## Request of information on Principia Report.

### Clarifications from Principia in the text (in blue)

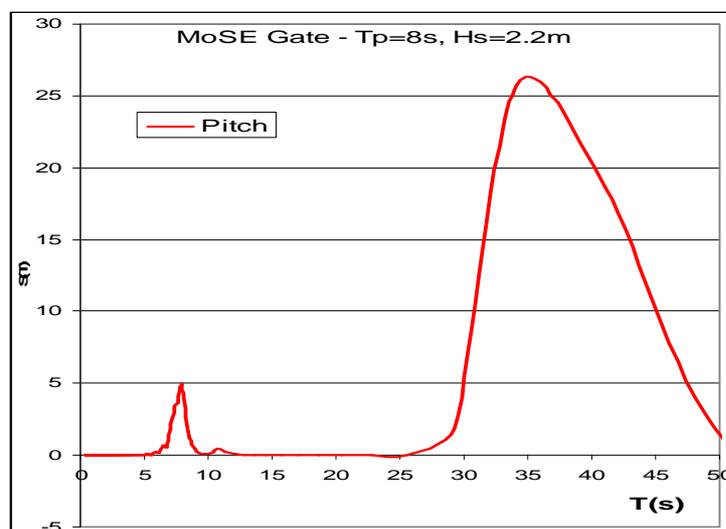
- Pag 8. The first bullet seems to shadow the advantage of MoSE gates. The sentence “For larger value the gate oscillates between two instable equilibrium inclinations .. “ seems not represented in the annexed plotters.

Can you please explain and give evidence of this statement?

Referring to the plots given on pages 26 and 27, I has been concluded that :

- Mean inclination of the MoSE gate is not the same for the two sea state ( $H_s=2.0m$  and  $H_s=2.2m$ )
- Stable behaviour is obtained for  $T_p=8.0s$  and  $H_s=2.0m$  instead of an instability occurrence (large unrealistic amplitudes) for  $H_s=2.2m$

Next plot of the spectral analysis of the time simulation illustrates the instability occurrence. Peaks are observed at both the wave excitation period (peak of the wave spectrum) and peak at the gate natural period (even if this peak is out of the range of the wave periods).

In conclusion, until sea state conditions is limited to  $T_p > 9s$  or  $H_s < 2.0m$  for  $T_p < 9s$  the MoSE gate remains a good design (see hereafter).
